Form 3160-5
(June 2015)UNITED STATES
DEPARTMENT OF THE INTERIOR
BUREAU OF LAND MANAGEMENTFORM APPROVED
OMB NO. 1004-0137
Expires: January 31, 2018**SUNDRY NOTICES AND REPORTS ON WELLS**
Do not use this form for proposals to drill or to re-enter an abandoned well. Use form 3160-3 (APD) for such proposals.**SUBMIT IN TRIPLICATE - Other instructions on page 2**

Enduring Resources is requesting the following changes:

W Lybrook Unit 758H

DRILLING PLAN: *Drill, complete, and equip single lateral in the Mancos-I formation*

WELL LOCATION AND ACREAGE DEDICATION PLAT

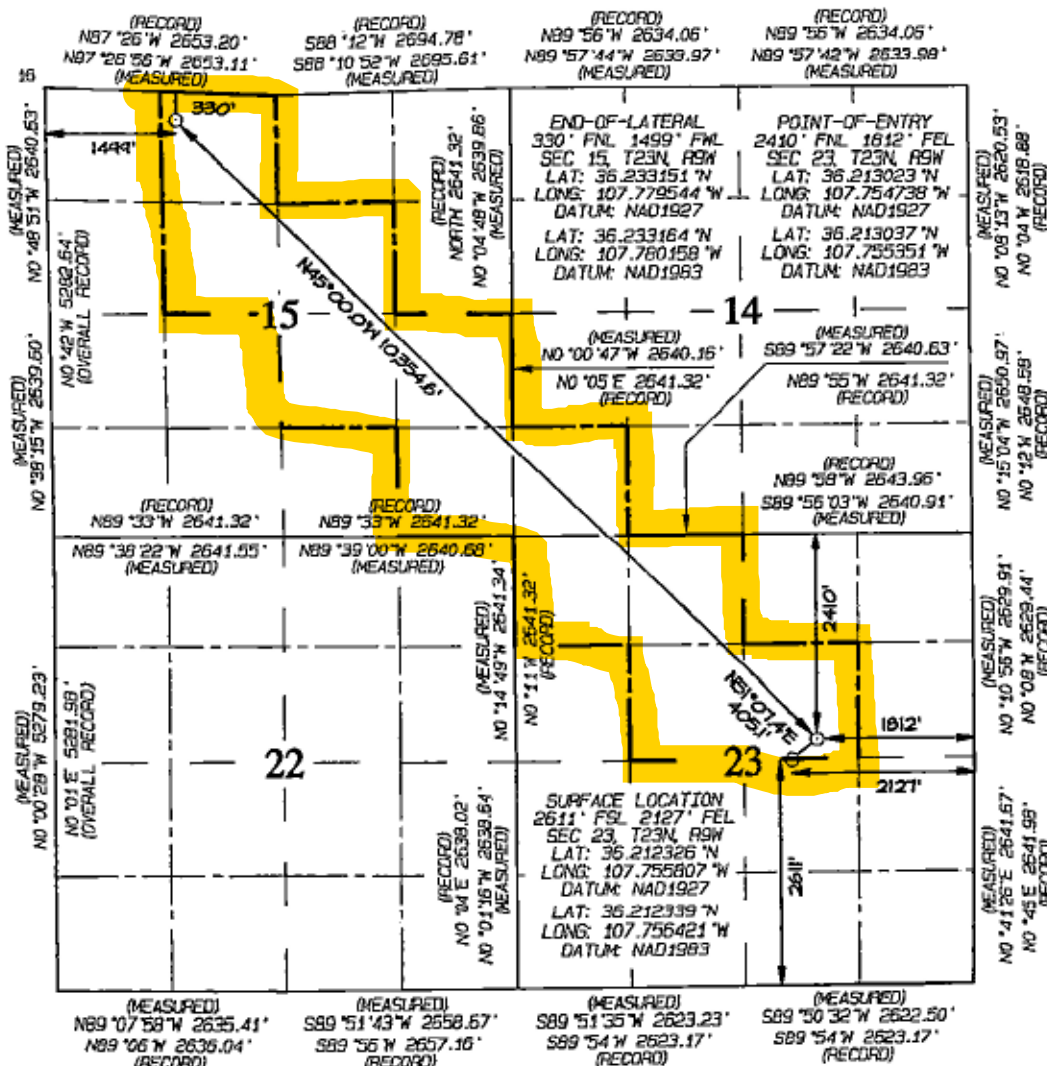
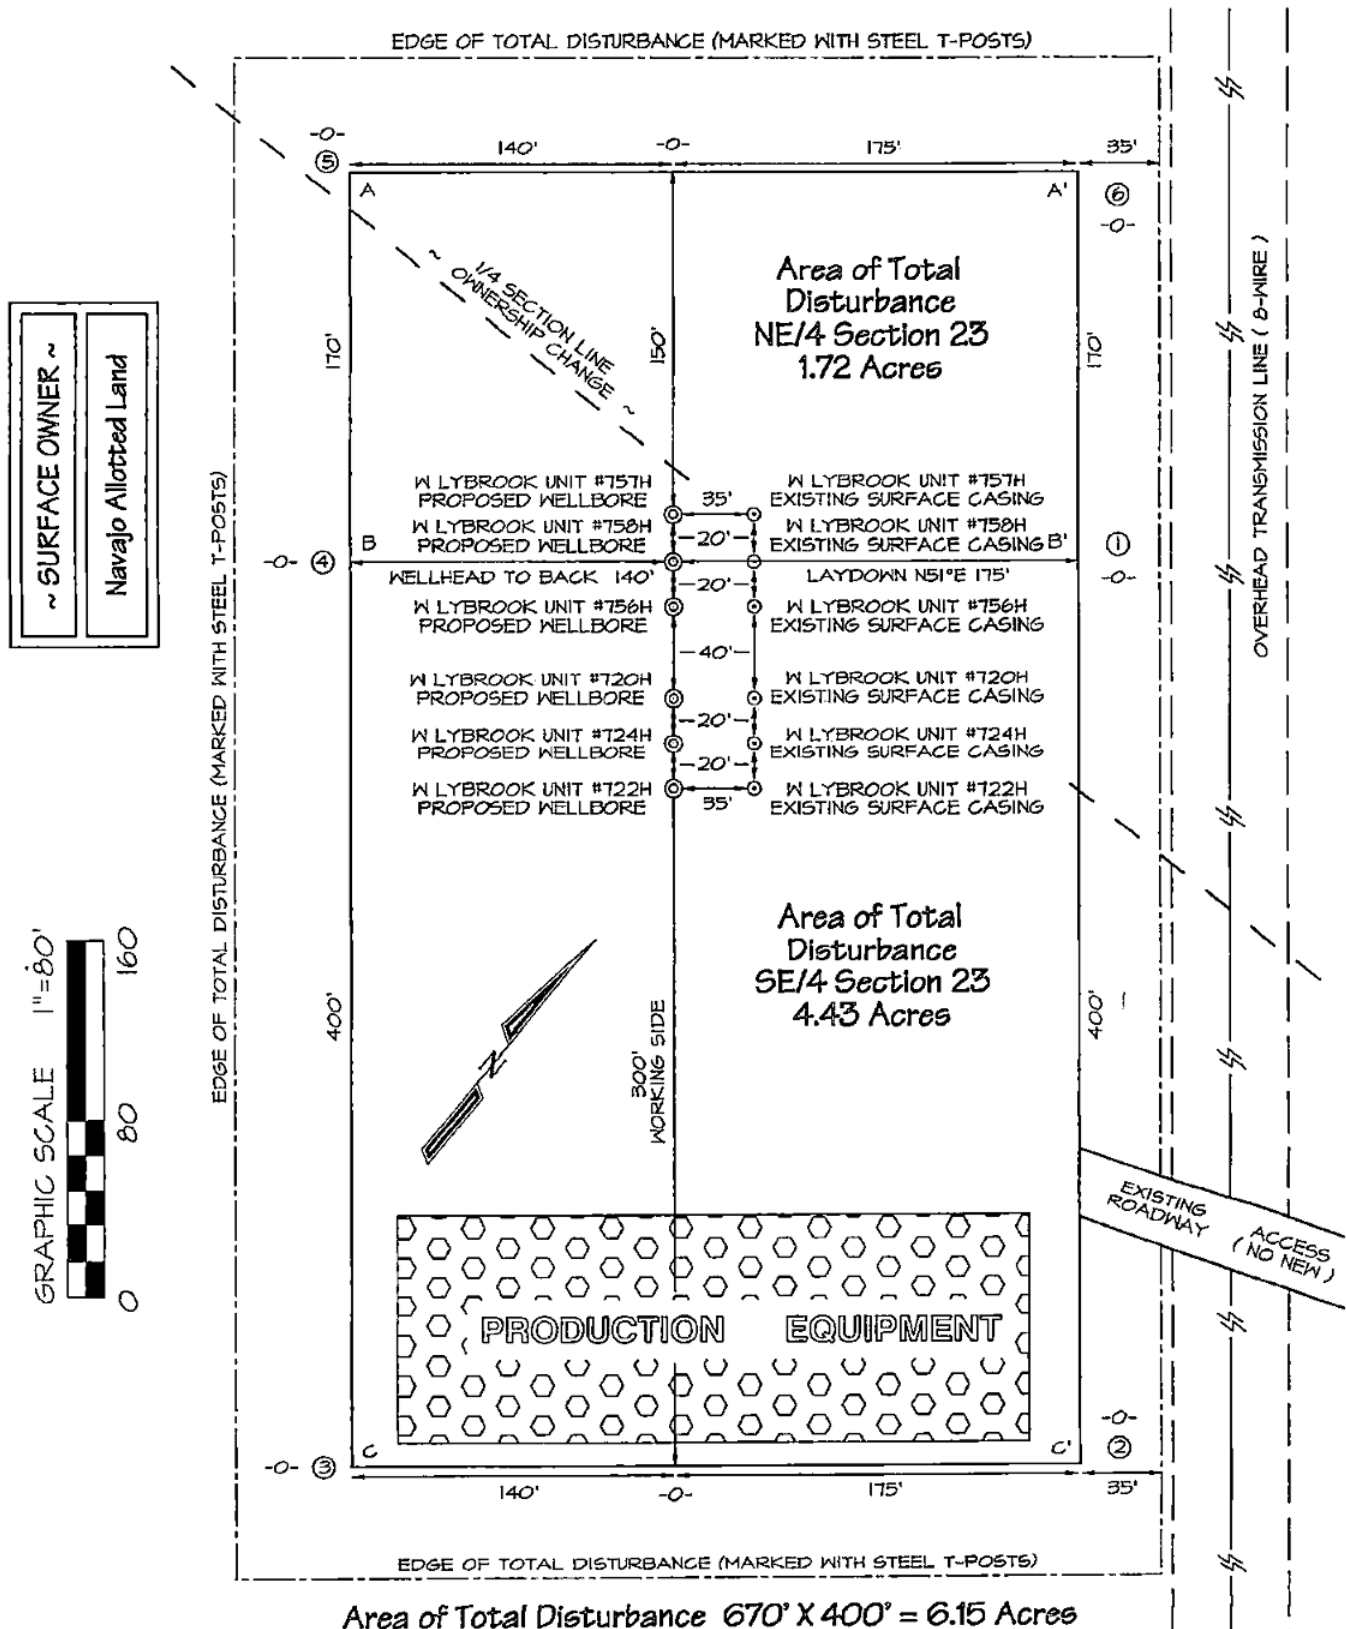
As part of the casing program change, Enduring proposes setting a larger surface casing. Installing a larger surface casing will require a new SHL because the existing surface casing has already been installed.

Updated C102 (SHL moved 35?; POE and BHL did not change)

UL or lot no.	Section	Township	Range	Lot	Feet from the	North/South line	Feet from the	East/West line	County
J	23	23N	9W		2611	SOUTH	2127	EAST	SAN JUAN

Date Revised: **FEBRUARY 20, 2020**
Survey Date: **OCTOBER 19, 2015**

Directional Drilling Plan Plan View & Section View

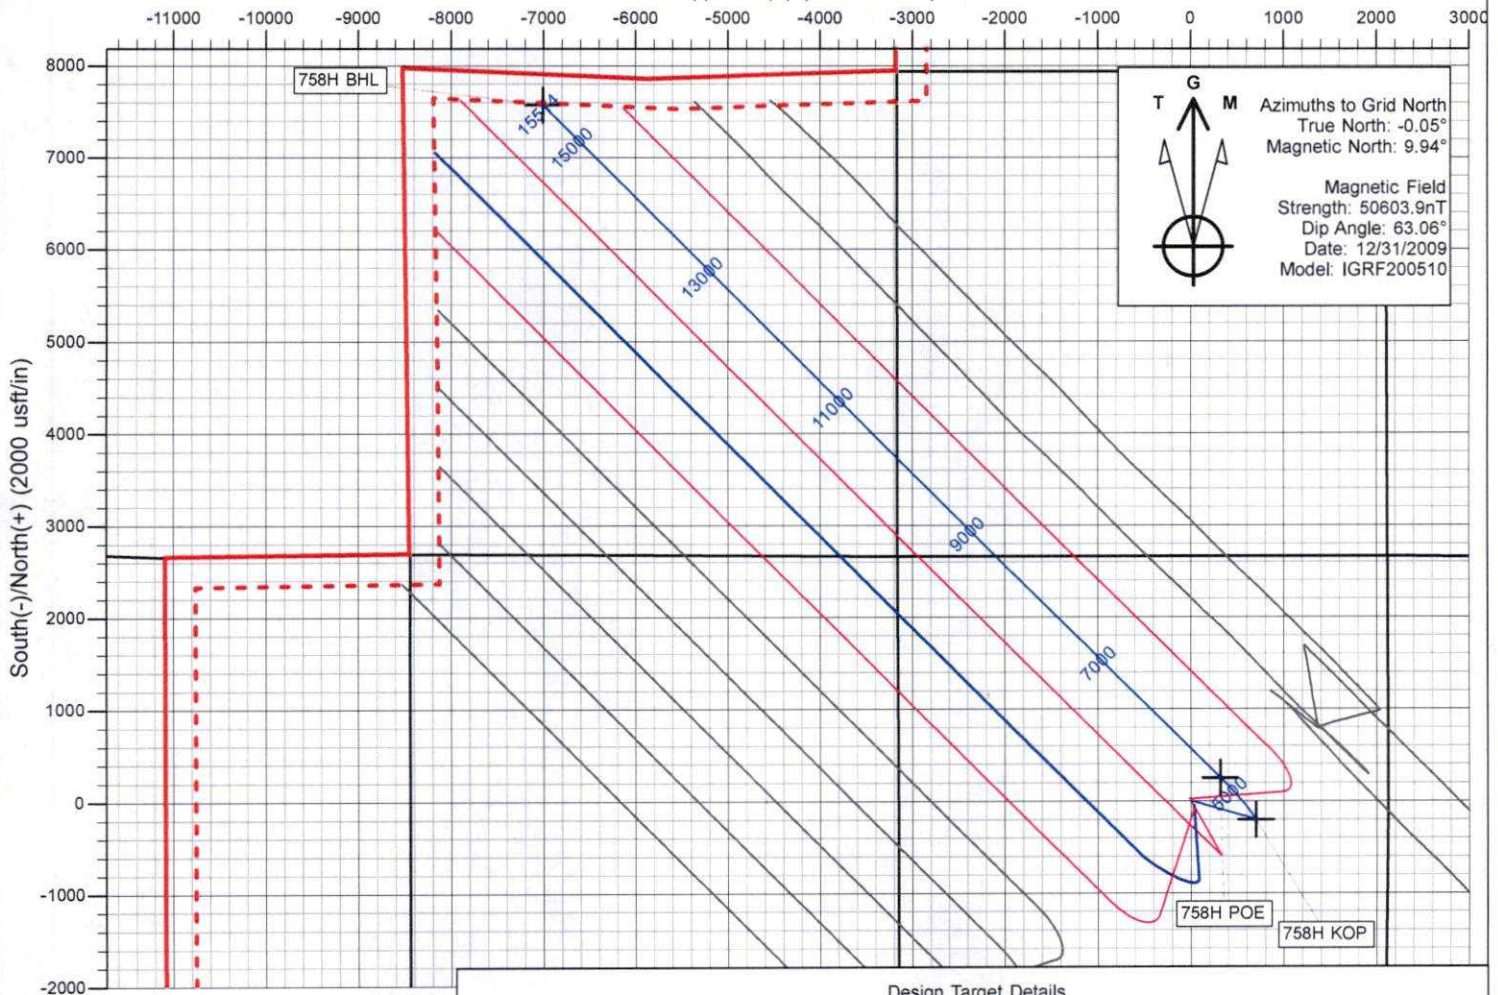
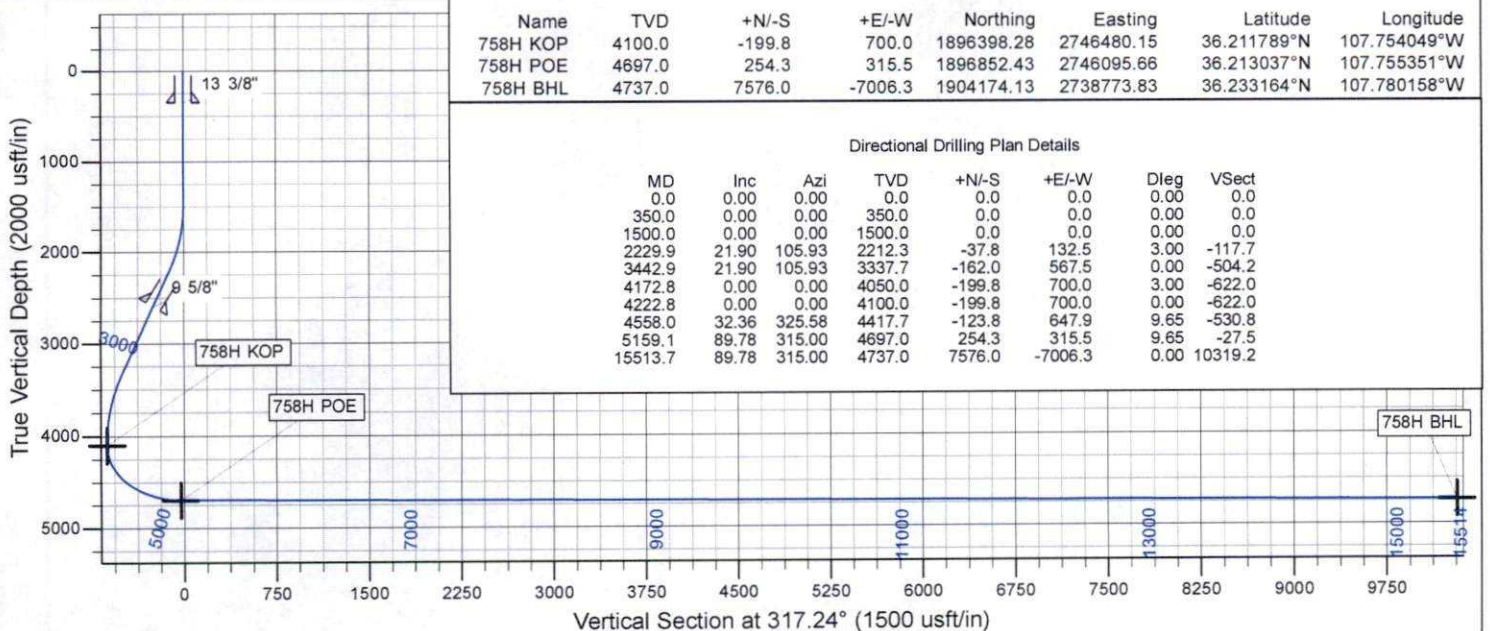
Updated directional drilling plan (updated to reflect new SHL)
